APPLICATION NO: 13/00756/FUL		OFFICER: Mrs Wendy Hopkins
DATE REGISTERED: 10th May 2013		DATE OF EXPIRY : 9th August 2013
WARD: Leckhampton		PARISH: LECKH
APPLICANT:	Martin Scott Homes	
LOCATION:	Leckhampton Industrial Estate, Leckhampton Road, Cheltenham	
PROPOSAL:	Demolition of existing buildings and residential development comprising the construction of 28 dwellings

ADDITIONAL REPRESENTATIONS 11th – 13th November 2013

Demolition of existing buildings and residential development comprising the construction of 28 dwellings. Leckhampton Industrial Estate, Leckhampton Road, Cheltenham, Gloucestershire, GL53 0AL, by Martin Scott Homes (205 Leckhampton) Ltd.

ANALYSIS OF THE PROPOSED DEVELOPMENT AT 205 LECKHAMPTON

Proposed Site Layout

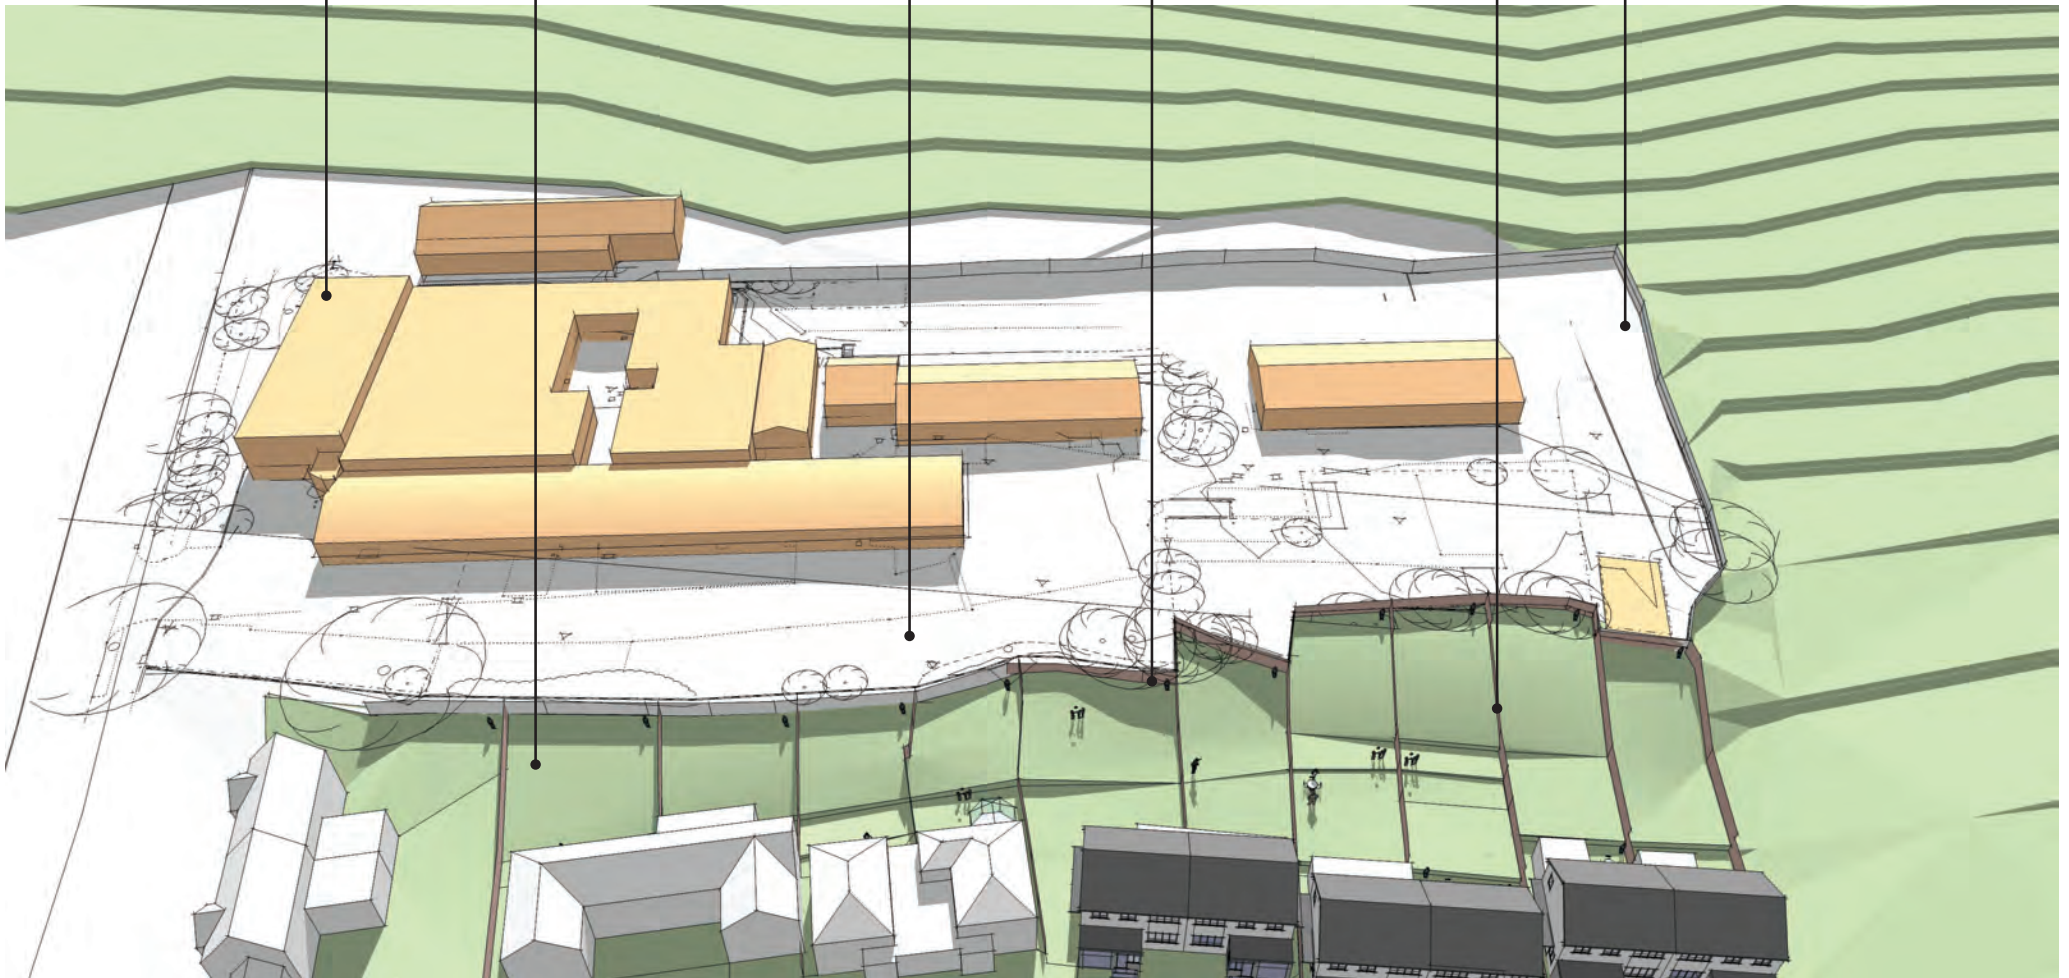
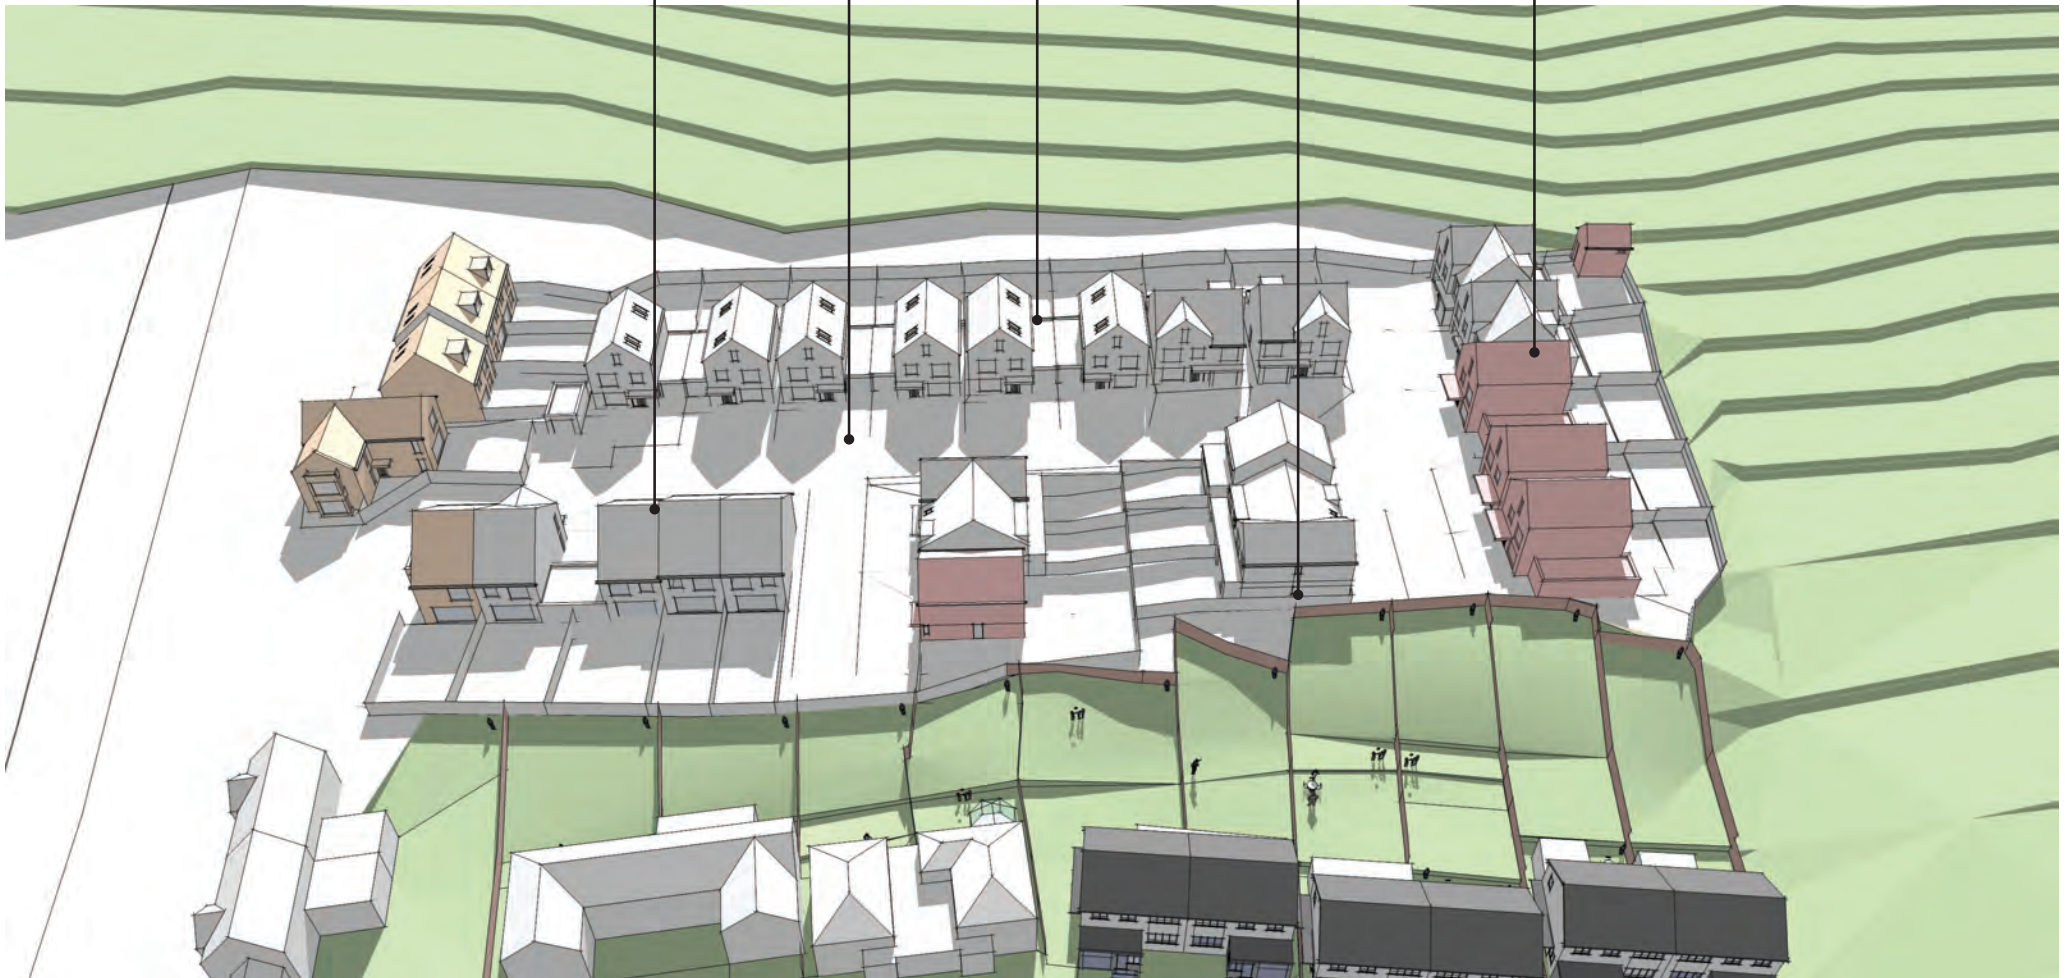
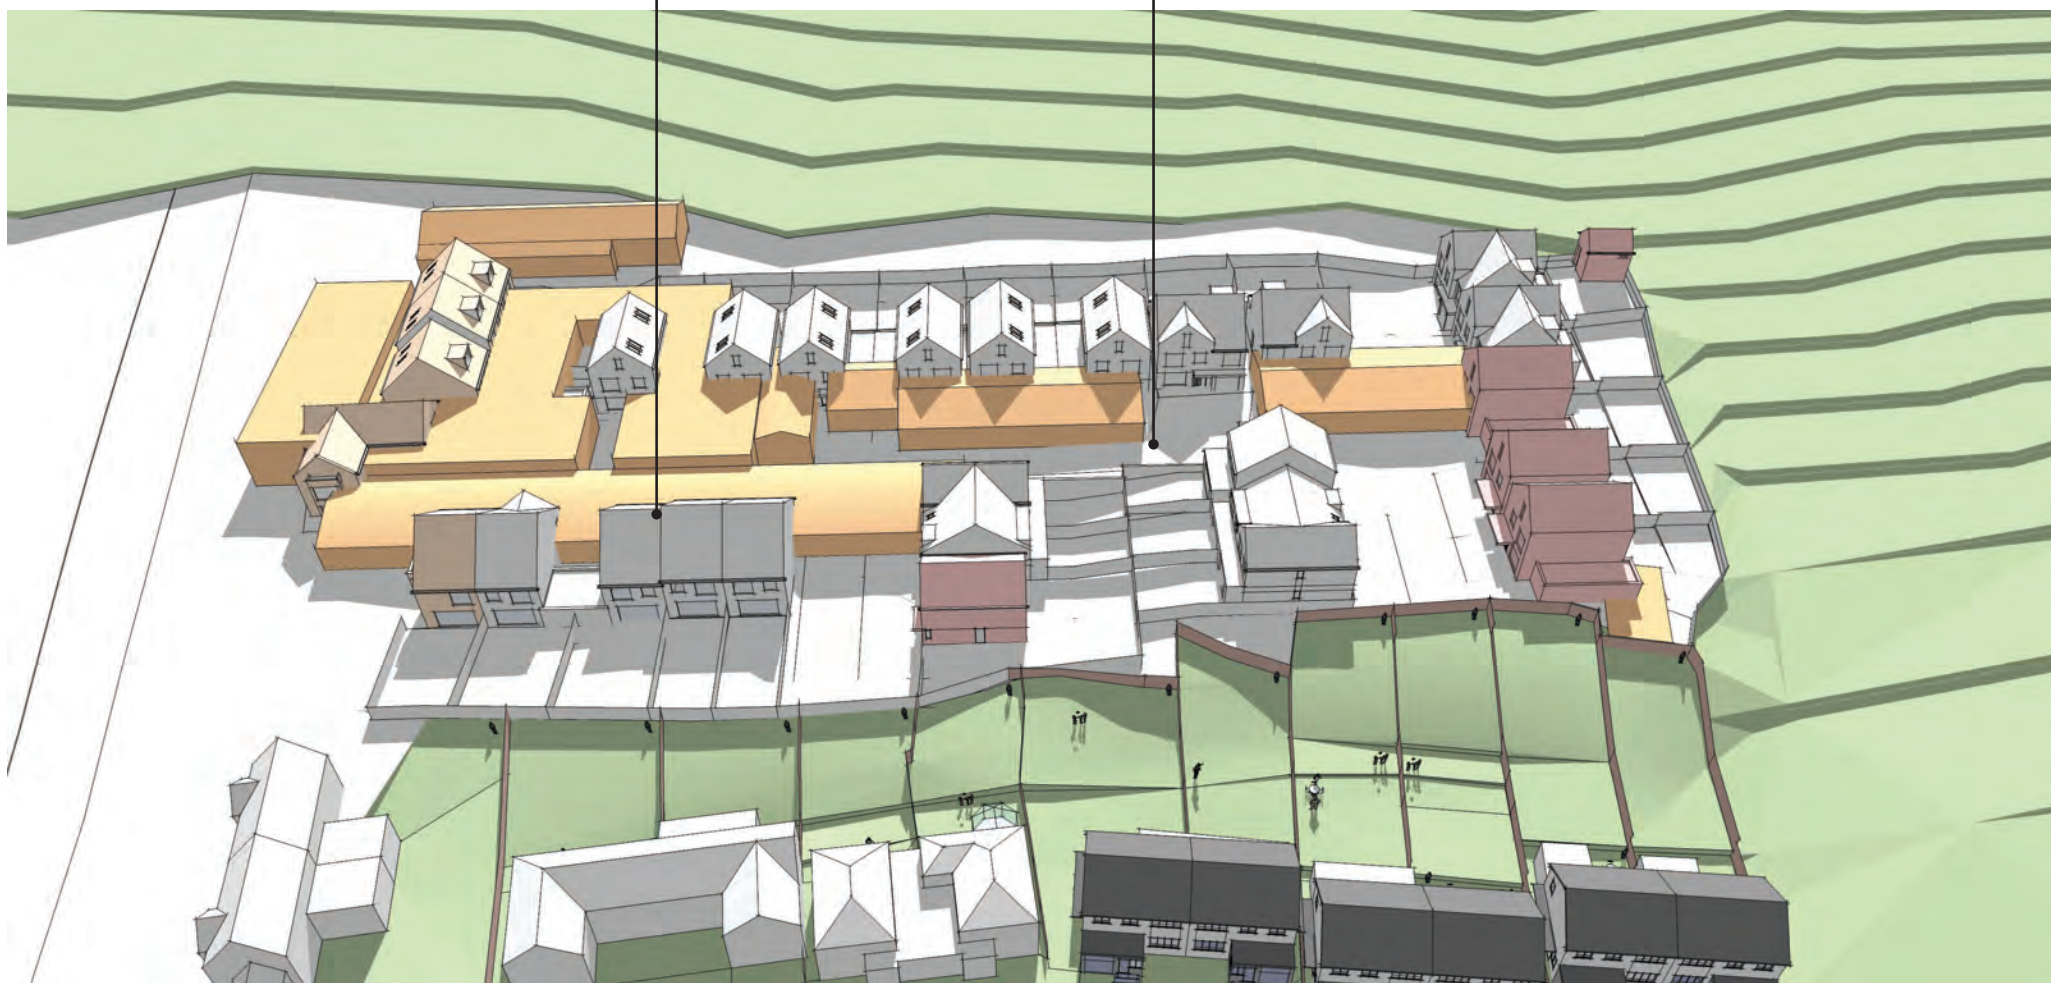
Terrace of 3 storey properties close to the boundaries

2 and 3 storey properties

Proposals tight to boundary

Access road in centre of site pushes development to boundaries

Proposals overlook existing houses

Significant increase in density and volume of building on the site

Large extent of proposals extend beyond and above envelope of existing buildings

View 4 - Proposed Site

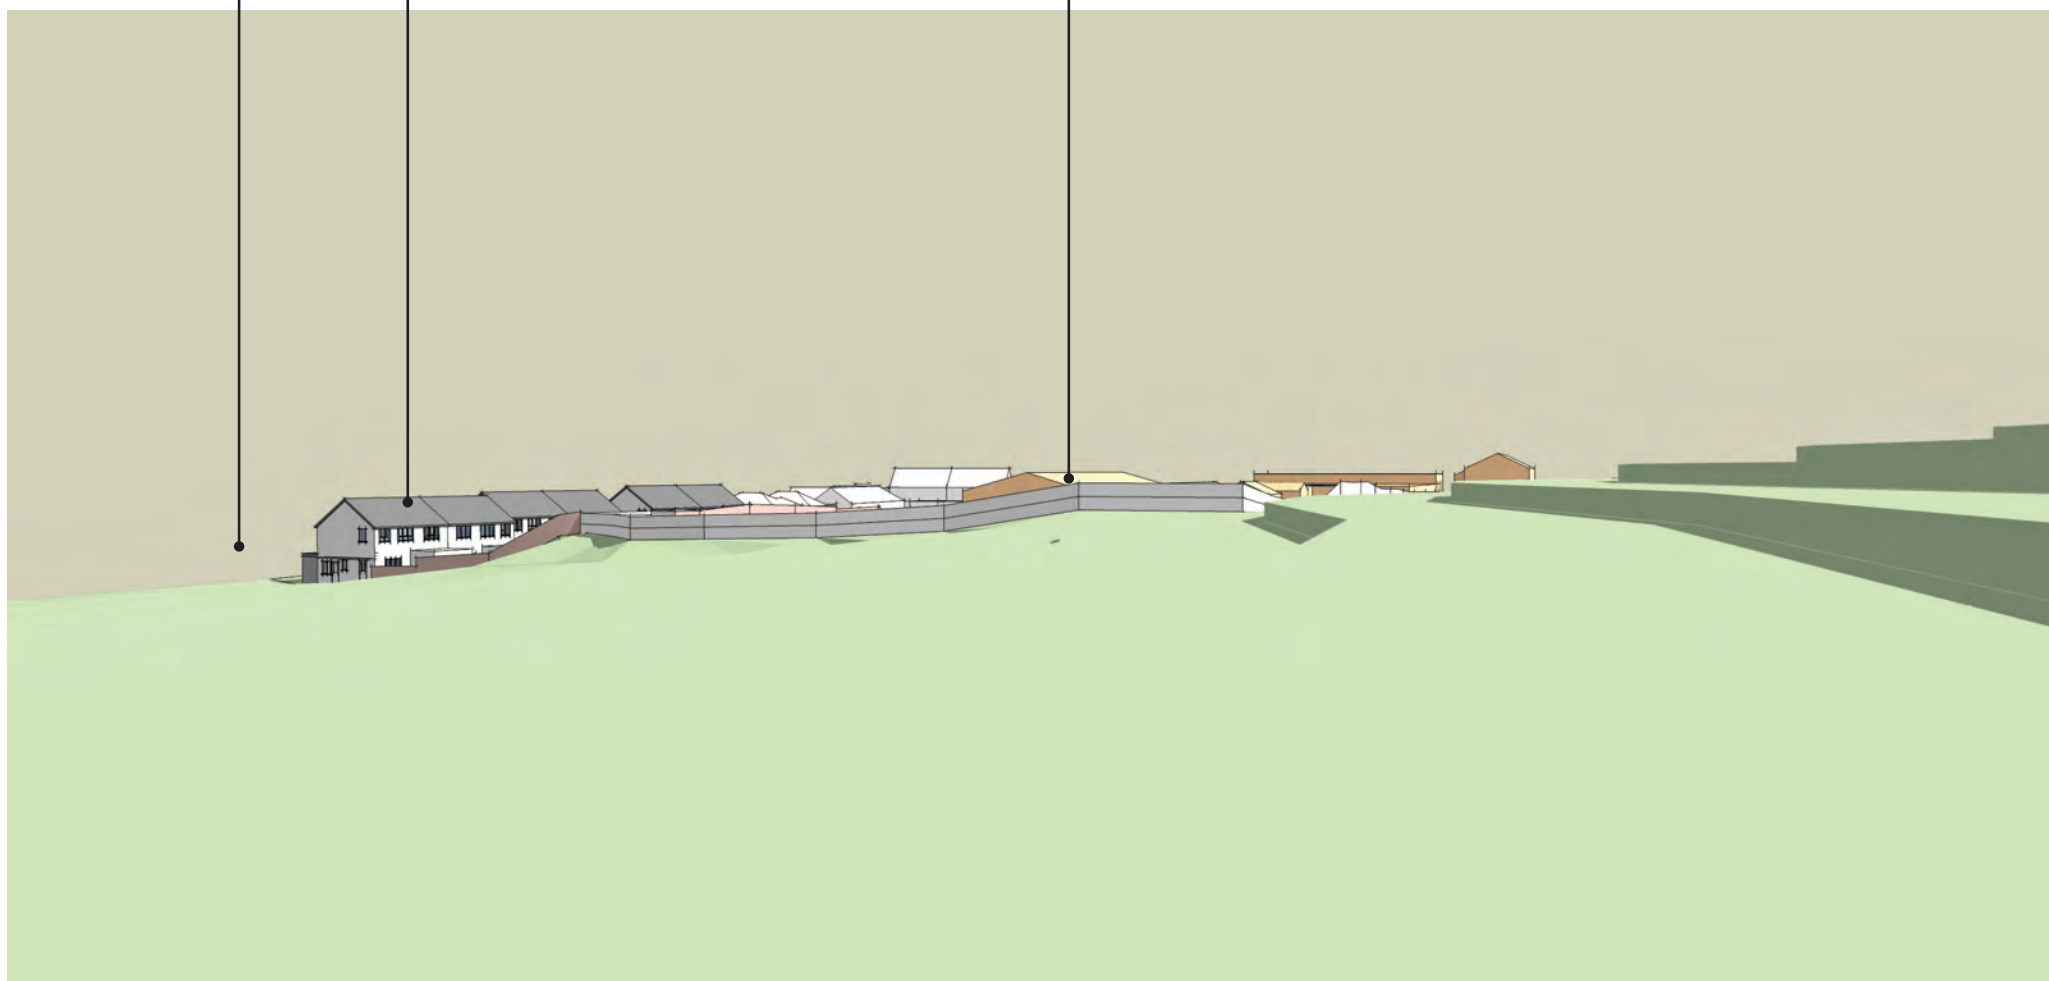
Proposed 3 storey development has a significant visual presence from the AONB

Shadow Study - 21 December @ 12.00

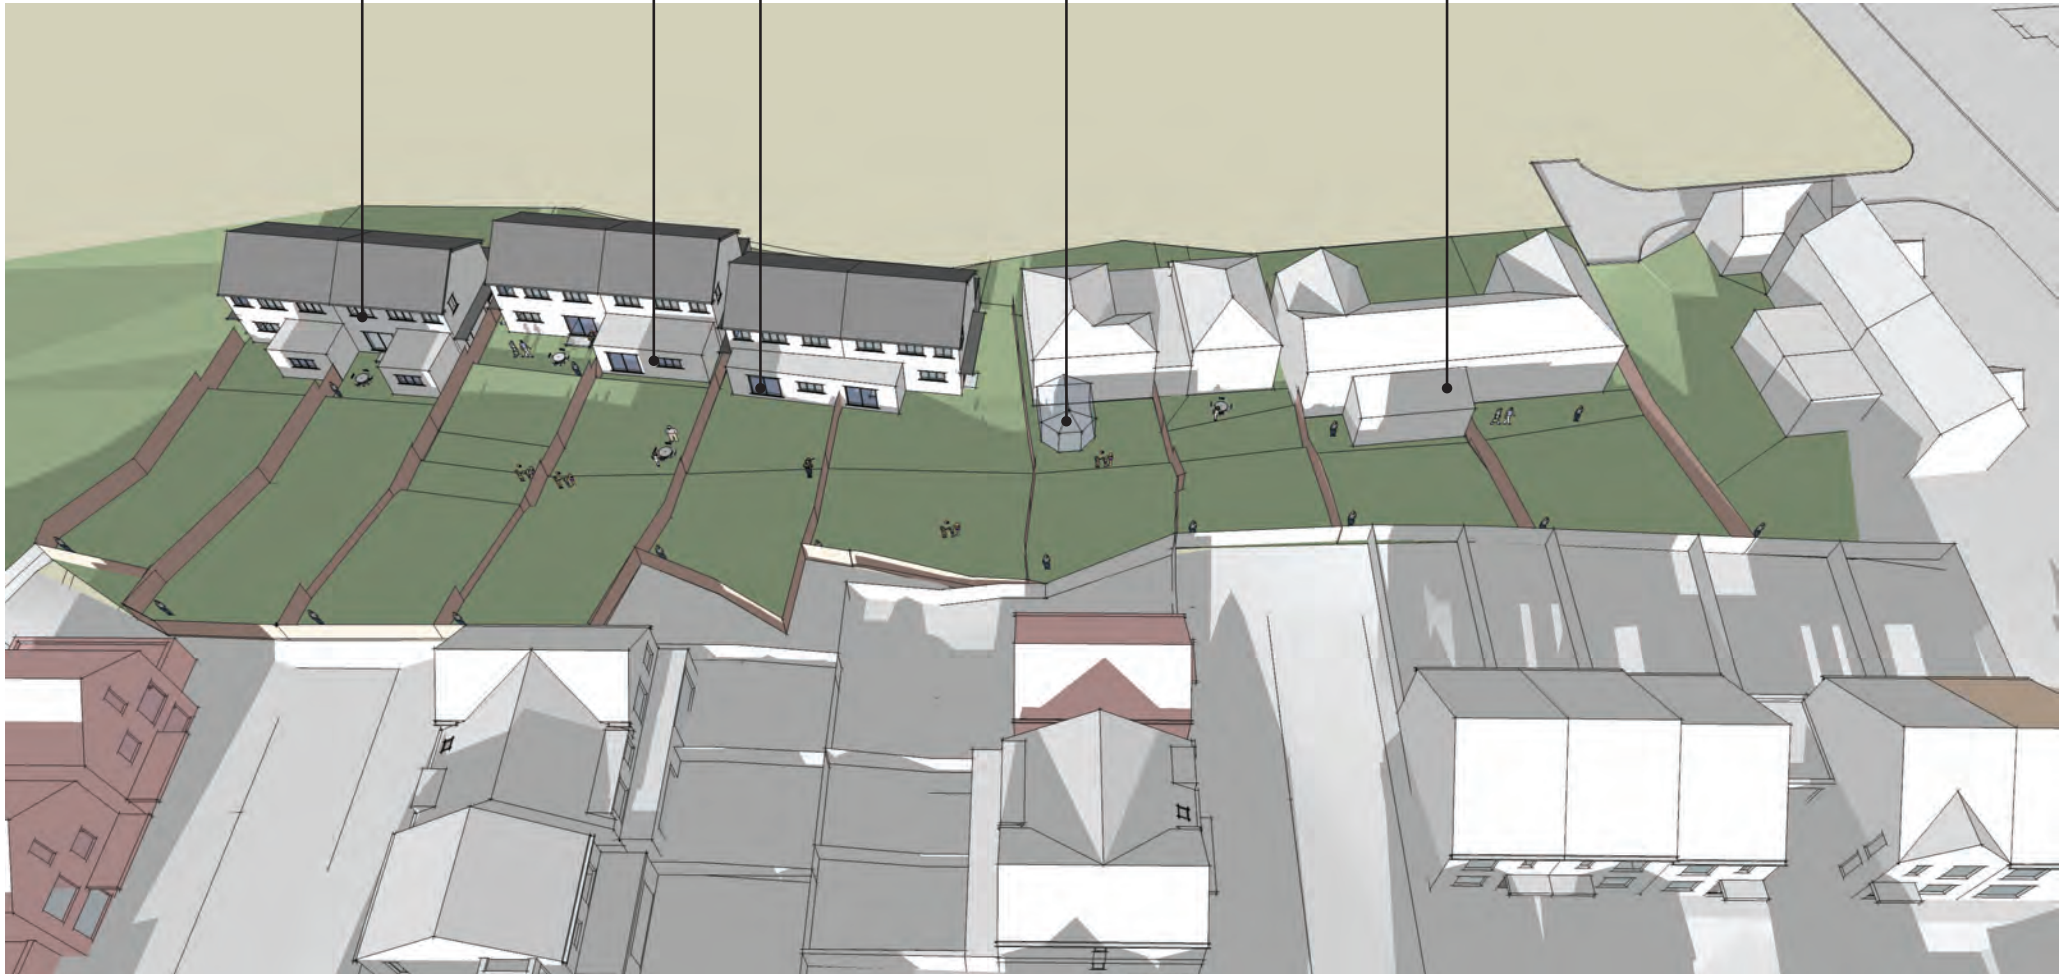
The elevated site, height of the bank and orientation of the site has a significant affect of the extent of shadows. Any properties facing due north and close to the boundary will create a permanent shadow of the adjoining gardens

Shadows cast by plot 18 across the kitchen
window and the majority of the garden at midday

Shadows cast by plot 18
across the dining room
window and the whole of
the garden at midday

Shadows cast by plots 24 to 26 across the whole
garden and ground floor facades at midday
